Purpose Note: The Purpose Of This Revision Is To Replace The Single Large Raingarden With Two (2) Smaller Raingarden And Revise Grades Accordingly On Lot 2. Add Stormwater Management Details On Sheet 2 And Remove The Planting Plan On Sheet 3.

REVISED

SUPPLEMENTAL PLAN LANDSCAPE, TOPOGRAPHIC AND SOILS

MULLIN PROPERTY

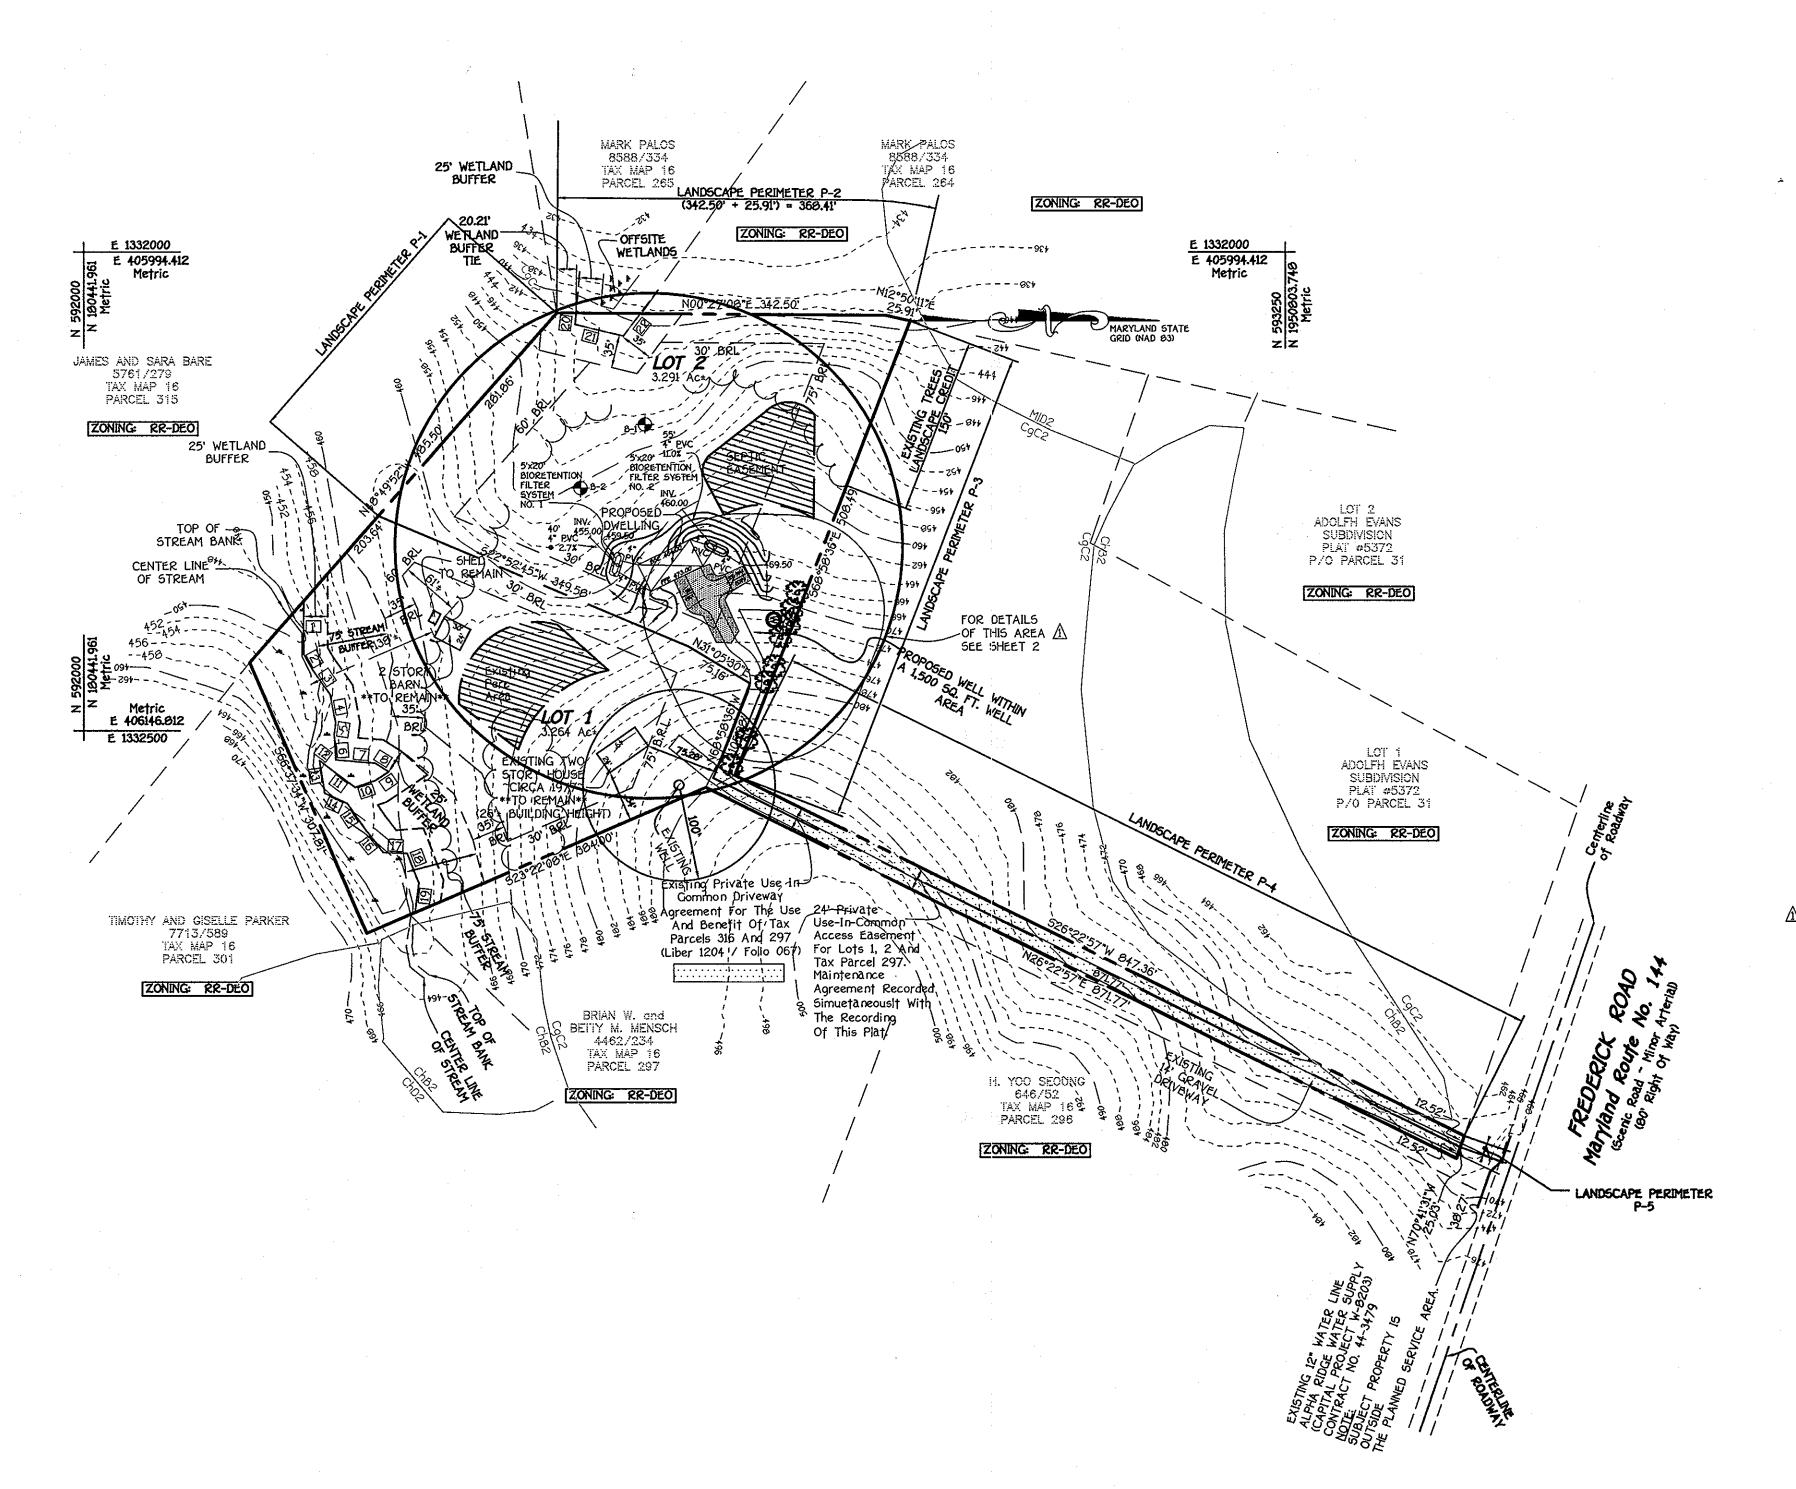
k Se	e	Revision	Note	#1/	Credit	given for	existing	trees.

DATE REVISION Eliminated the large Bioretention Filter System at the rear of Lot 2 and replaced it with two (2) smaller Bioretention Filter Systems located at the rear of the proposed house. Also, resited the proposed house approximately 10 feet to the Southeast and re-graded the area to accomodate the 03/6/09 Bioretention Filter Systems. Revised General Note No. 24 as required by by these changes. Added existing trees along landscape perimeter P-3 for

landscaping credit, eliminated planting details, chart and notes.

STORMWATER MANAGEMENT BIORETENTION PLAN, PROFILE, & DETAILS

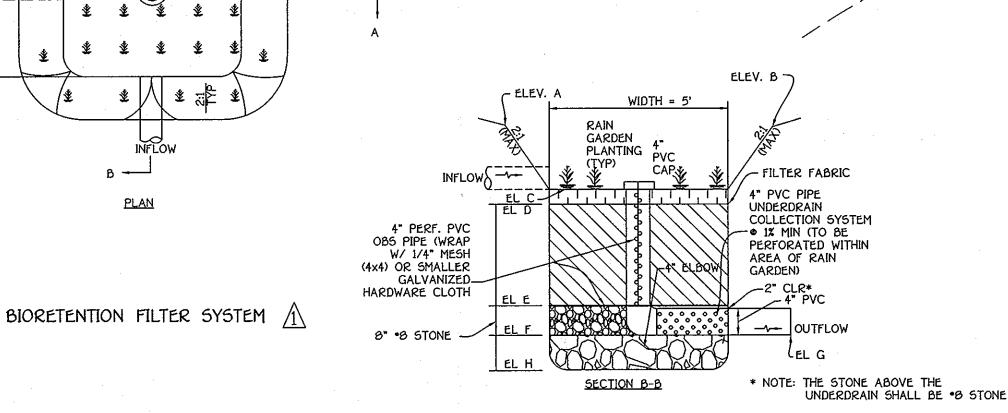
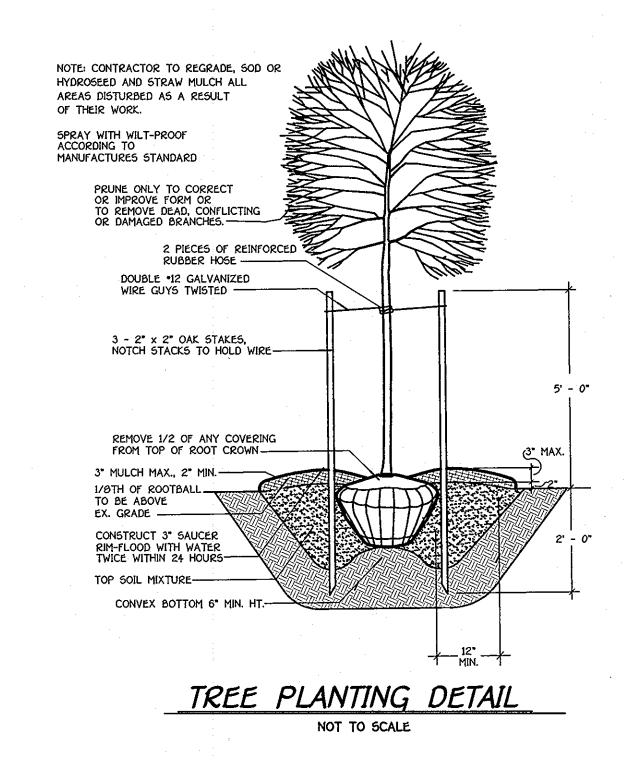
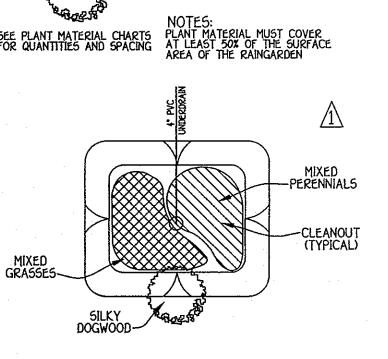
DATE REVISION NO. Ipdated the plan view in accordance with the elimination of the large Bioretention Filter System in the rear of Lot 2 and eliminated all details for that system. Added plan view 03/6/09 and details for the two (2) new Bioretention Filter Systems. Added existing trees for landscaping credit.

STORMWATER MANAGEMENT BIORETENTION PLANTING PLAN & DETAILS

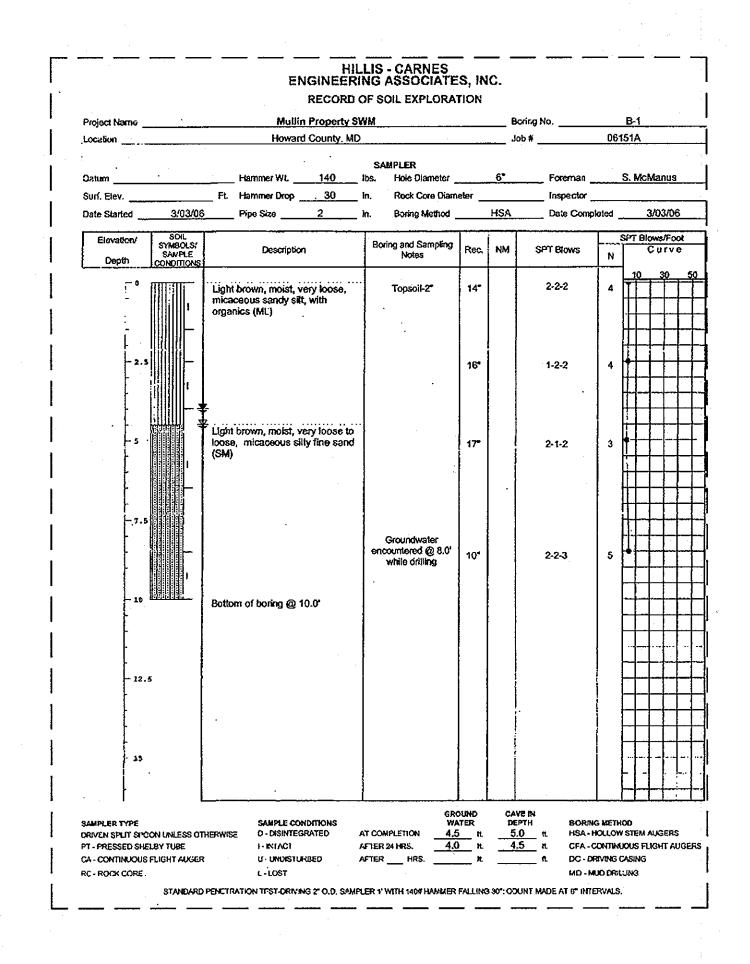
DATE REVISION Eliminated the Planting Plan for the large Bioretention Filter System. Those details can be found on Sheet 2. 03/6/09 Also Eliminated All Londscaping Chart And Shrub Detail.
